Subject: Collin County Healthcare Facility, Parking Garage, and Medical Examiners  
Revised PCO No. 065; RFI #244 ME and HC Location and Data for Time Clock

Project:  
224057- Collin County Public Health Buildings  
2300 Bloomdale Rd  
McKinney, TX 75071

Issue No. 065 - RFI #244 ME and HC Location and Data for Time Clock Amount

## RFI #244: ME and HC - Location and Data for Time Clocks.

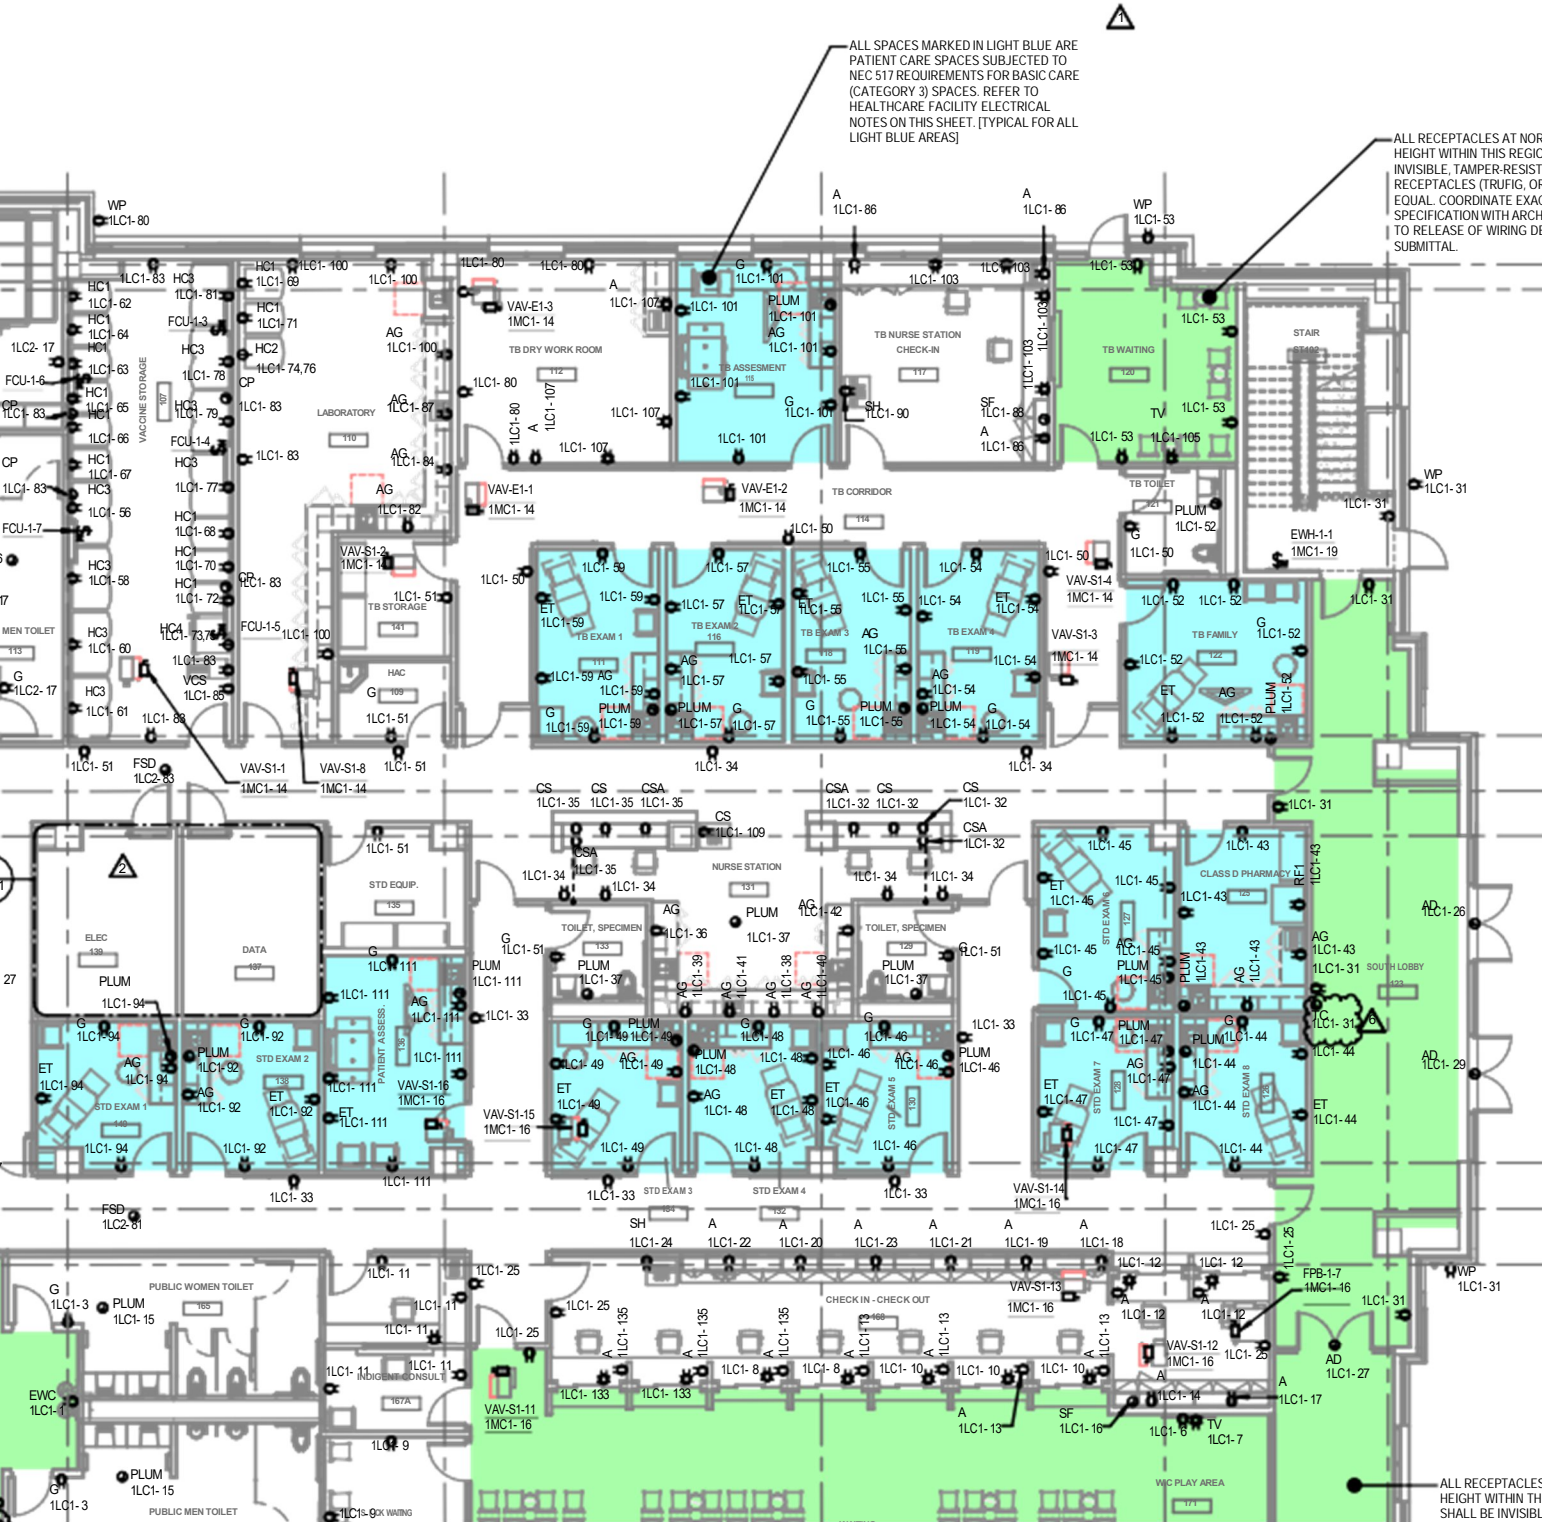
Attached are the suggested locations for the time clocks. Please incorporate these locations and the necessary data into the drawings. The owner anticipates that these will require CAT 6 data drops, along with back boxes and blank stainless-steel covers.

PLEASE SEE ATTACHED REQUESTED UPDATED SHEETS FROM ELECTRICAL AND LOW VOLTAGE TO INCORPORATE THE TIME CLOCKS.

1. HC-T2.01 Add (2) data rough locations with conduit sleeves and blank wall plates for POE Time Clocks.
2. HC-T2.02 Add (1) data rough locations with a conduit sleeve and a blank wall plate for a POE Time Clock.
3. ME-T2.10 Add (2) data rough locations with conduit sleeves and blank wall plates for POE Time Clocks.
